(Shearon Harris Nuclear Power Plant, )  
Units 1 & 2) )

AFFIDAVIT OF ROBERT W. PRUNTY, JR., IN SUPPORT OF  
APPLICANT'S MOTION FOR SUMMARY DISPOSITION  
OF EDDLEMAN CONTENTION 132C(II)

APPENDIX D  
RECOMMENDED CONTROL ROOM EQUIPMENT ARRANGEMENT

**A FINAL REPORT ON THE  
HUMAN FACTORS ENGINEERING  
ANALYSIS OF THE SHNPP UNIT 1  
CONTROL ROOM EQUIPMENT ARRANGEMENT**

FIGURE 1

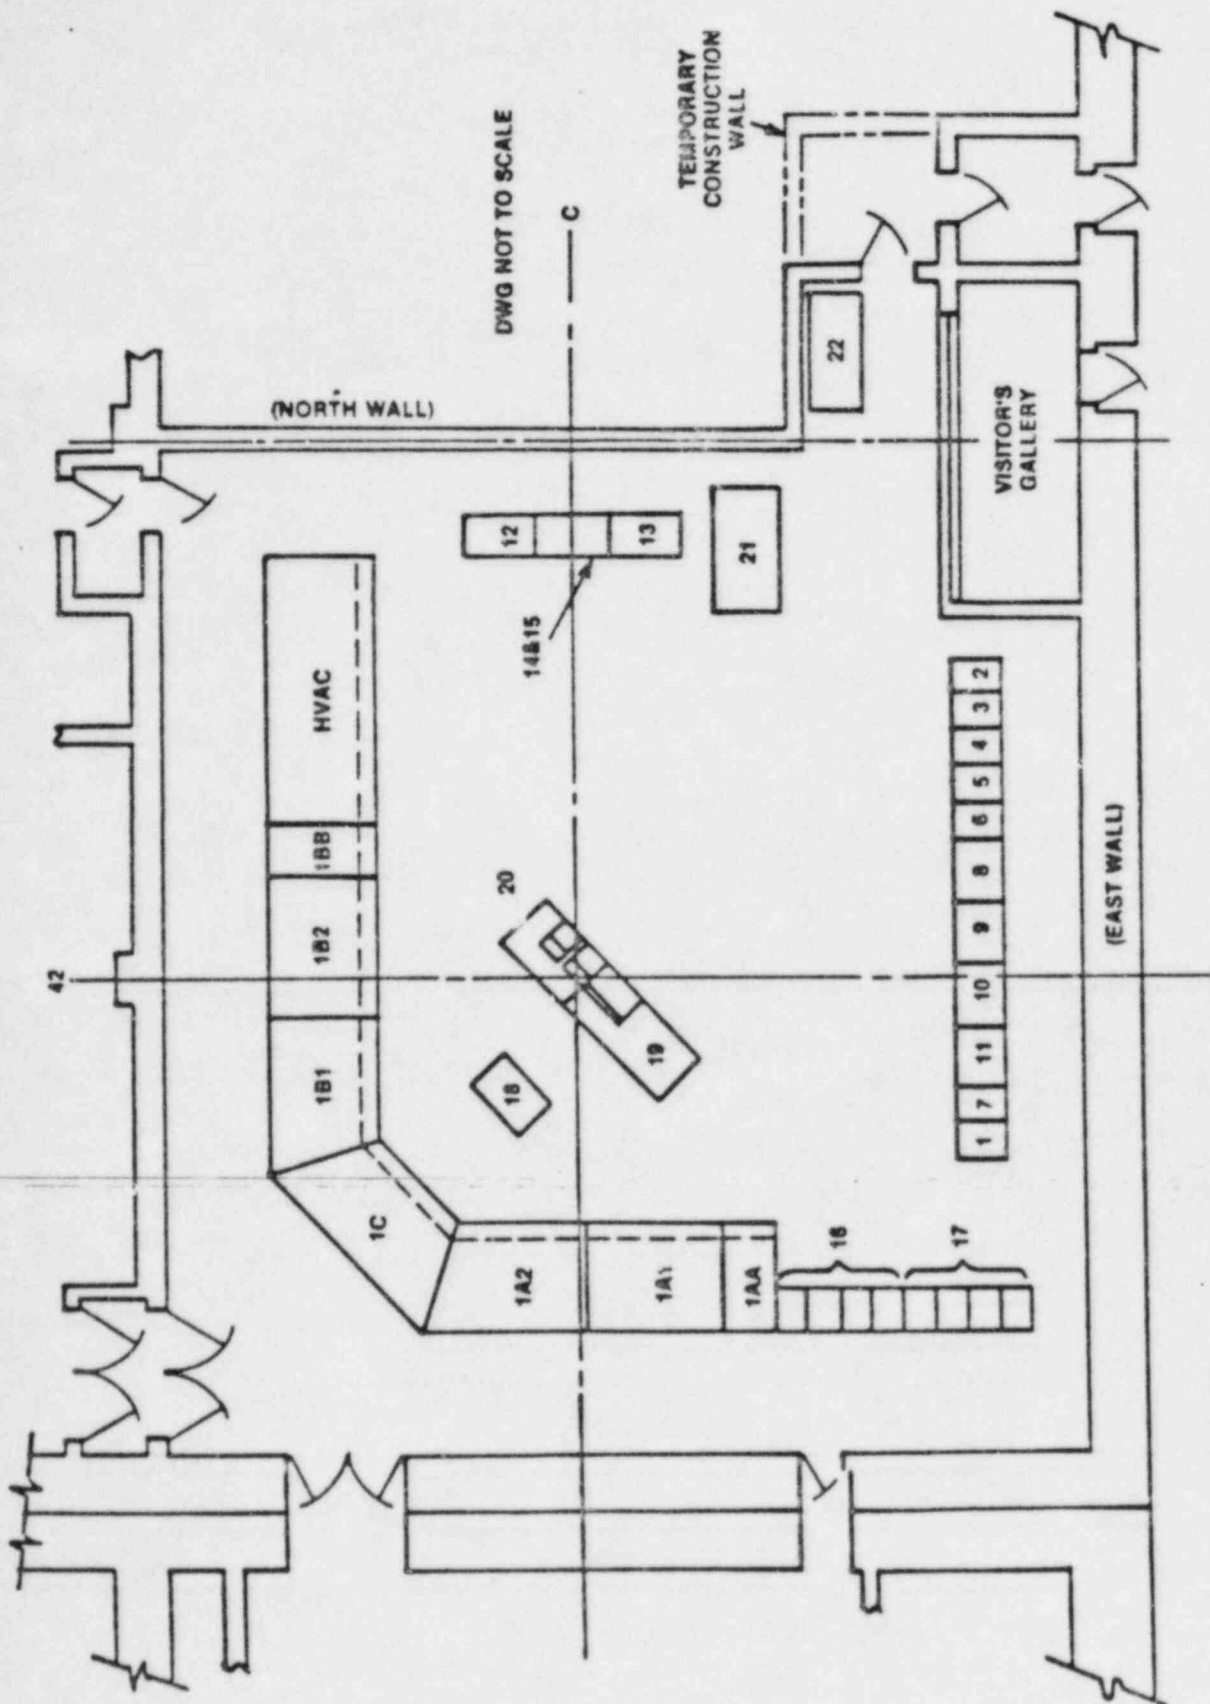
a. A review of the new engineering information listed in Addendum 1 indicated that, in spite of the movement of the Radiation Monitor cabinets (equipment numbers 12 through 15 in Table 1) to the north wall (Figure 1), some potential human factors problems still remained. The major areas of concern were:

c. Based on the preceding synthesis, visual angles for various operator positions were calculated for equipment numbers 1 through 15 for the EBASCO arrangement shown in Figure 1. These visual angles were then assumed to represent a correlate with the approximate signal densities and their associated error rate probabilities for these various pieces of equipment. The following three positions were used for these calculations:

c. In Figure 1 the location of the Air Pack and Respirator Storage cabinet (equipment number 22) appears to be where traffic could interfere with operator access to it. The location shown in Figure 2 eliminates this potential problem.

c. Essex recommends that the proposed arrangement shown in Figure 2 be adopted for the control room equipment in the SHNPP Unit 1. Latitude of placement from those locations shown for most equipment can be made to accommodate building structures such as steel beams and supports. Such accommodations should not exceed 6 inches forward or backward, or left or right for equipment numbers 1 through 5, 8 through 11, 12 through 15, and 18 through 21. Equipment numbers 6 and 7 may be moved back (east) to the limit needed for rear door access. They may also be moved left (north) 8 to 10 feet with no impact. Equipment number 22 should remain approximately where it is; however, aligning the long side against the east wall would be acceptable.

FIGURE B

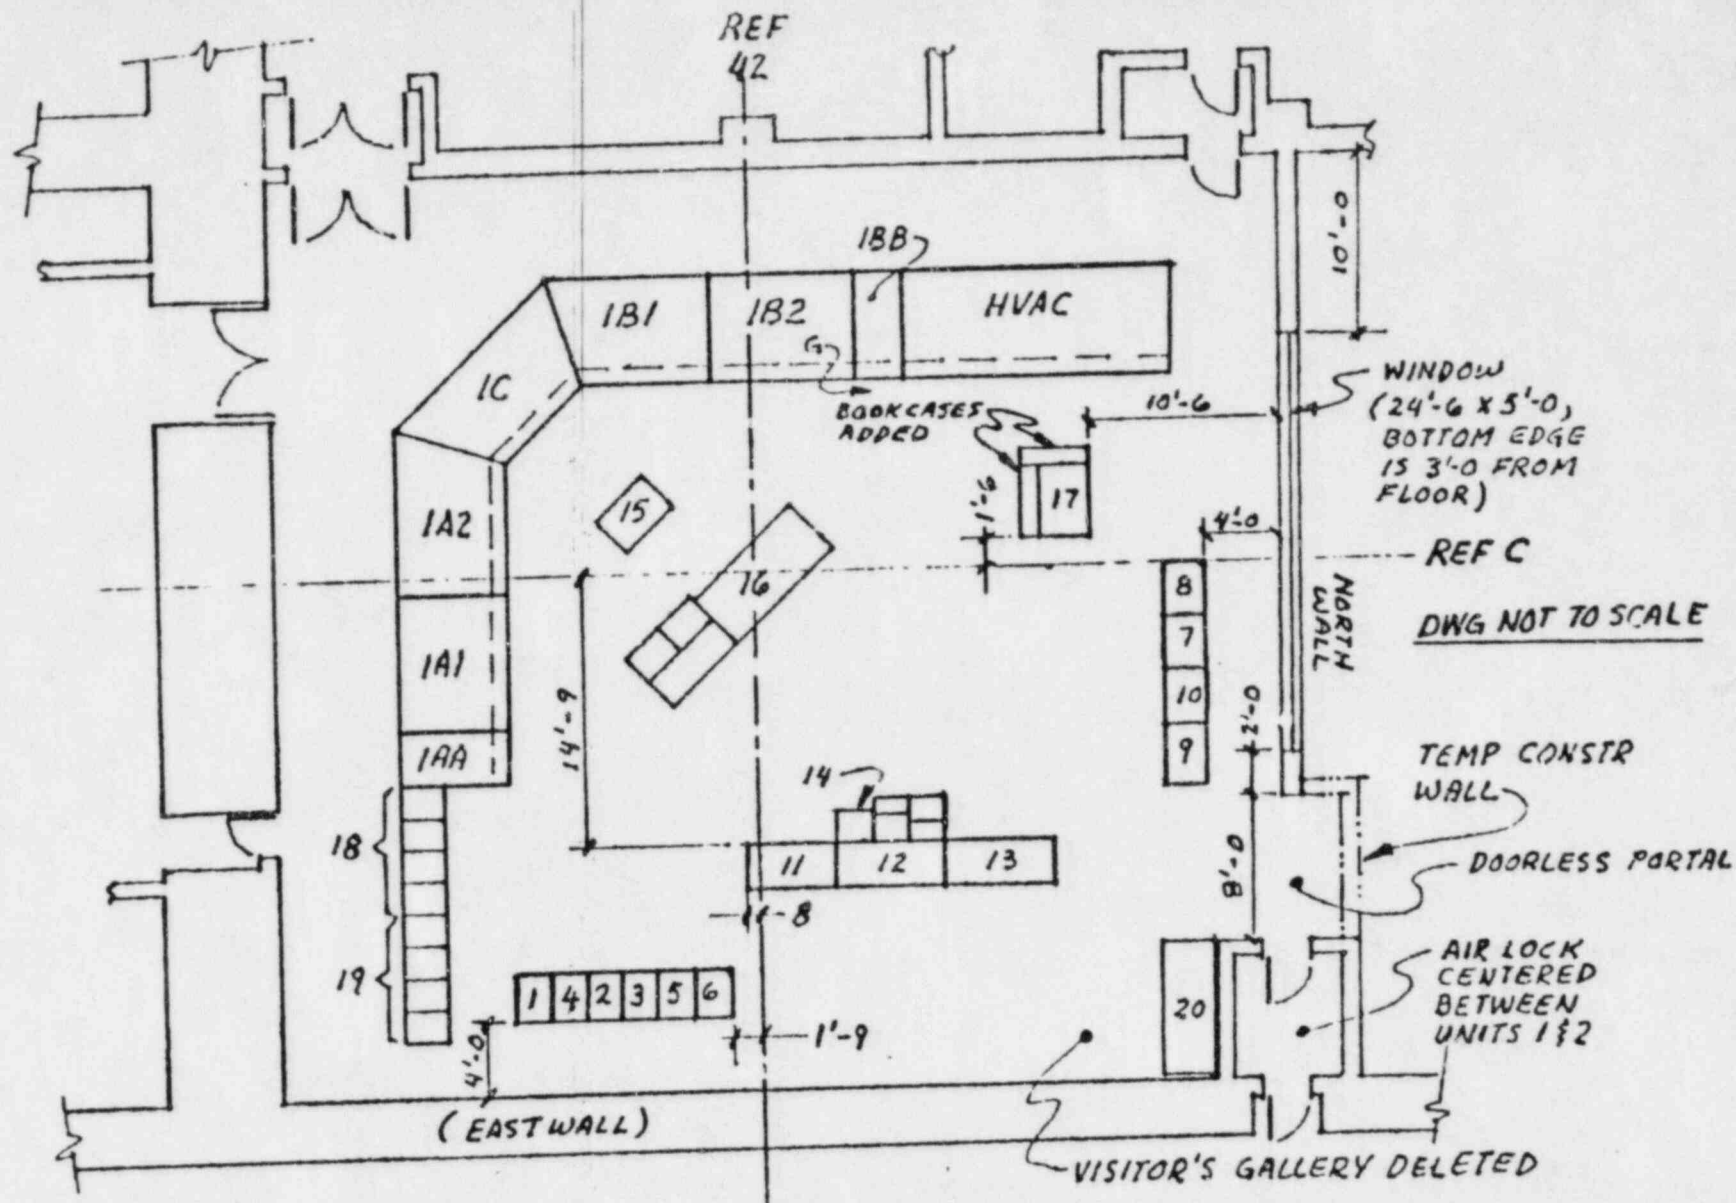
The original EBASCO control room equipment arrangement in Figure A shows the Radiation Monitor cabinets blocking the operator's view of the row of vertical cabinets located near the east wall. This problem can be solved by moving the Radiation Monitor Cabinets. However, an additional problem then surfaces.

The Essex-proposed rearrangement shown in Figure B attempts to partially solve both problems. While part of the Radiation Monitor equipment is moved a little farther from the operator's desk and the control panel, it no longer significantly blocks the view to the vertical cabinets from the control board. Additionally, the long string of cabinets has been separated into two groups, reducing by half the amount of cabinet front panel area presented to the viewer when looking in either direction.

Other features of this proposed rearrangement would be: 1) to place the Generator and Start-Up Transformer Relay cabinets in a more accessible location to their related areas of the control board (sections 1B2 and 1BB which contain the main and emergency generators and the bus distribution controls and displays); and 2) to place the shift foreman's desk closer to the control board. This second feature better supports the CP&L operating philosophy of maintaining good visual access to the control board (for the shift supervisor) than does the EBASCO arrangement.
